# Access Compliance Report

## Public Rights-of-Way

### (Curb Ramps)

Intersection ID: 20823	Main Street: CROWN CENTRE DR	Cross Street: TOWER POINT DR	Location: E
ADA ID: 5F43394EC8EA	Ramp Type: PerpDiag	Initial Pass/Fail: Fail	Overall Compliance: No
Severity Score: 33.75			
Codes/Mitigation Info/Possible Solution		Field Measurements/Component Compliance

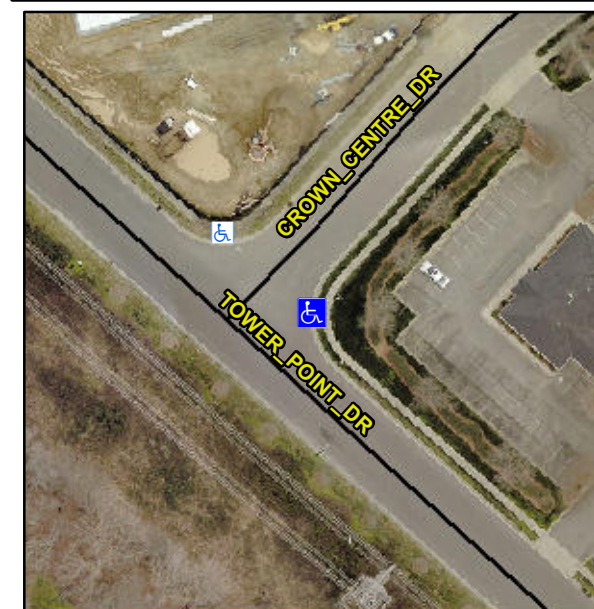
**R304.5.1, R304.2.2, R304.5.3**

Compliance	Description	Data	Compliance	Description	Data
N/A	Ramp Length (in)	48.0	No	Ramp Slope (%)	10.2
No	Ramp Width (in)	43.0	No	Ramp XSlope (%)	6.4
N/A	Flare Type LT	N/A	N/A	Flare Type RT	N/A
N/A	Flare Slope LT (%)	N/A	N/A	Flare Slope RT (%)	N/A
N/A	Flare Traversable LT?	N/A	N/A	Flare Traversable RT?	N/A
N/A	Landing Length (in)	N/A	N/A	DWS Provided?	N/A
N/A	Landing Width (in)	N/A	N/A	DWS Contrast?	N/A
N/A	Landing Slope (%)	N/A	N/A	DWS Length (in)	N/A
N/A	Landing X Slope (%)	N/A	N/A	DWS Full Width?	N/A
N/A	Landing Curb? (Y/N)	N/A	N/A	DWS Offset (in)	N/A
N/A	Shared Landing?	N/A			
N/A	Gutter Ponding?	N/A	N/A	Gutter Slope (%)	N/A
N/A	Gutter Lip Ht (in)	N/A	N/A	Gutter X Slope (%)	N/A
N/A	Painted X Walk1?	No	N/A	Painted X Walk2?	No
	X Walk 1 Direction	To NW		X Walk 2 Direction	To SW
N/A	X Walk 1 Width (in)	N/A	N/A	X Walk 2 Width (in)	N/A
	X Walk 1 Slope (%)	2.5		X Walk 2 Slope (%)	7.4
	X Walk 1 X Slope (%)	6.3		X Walk 2 X Slope (%)	4.2

**Remove & Replace Curb Ramp With Two New Directional Ramps or Equivalent.**
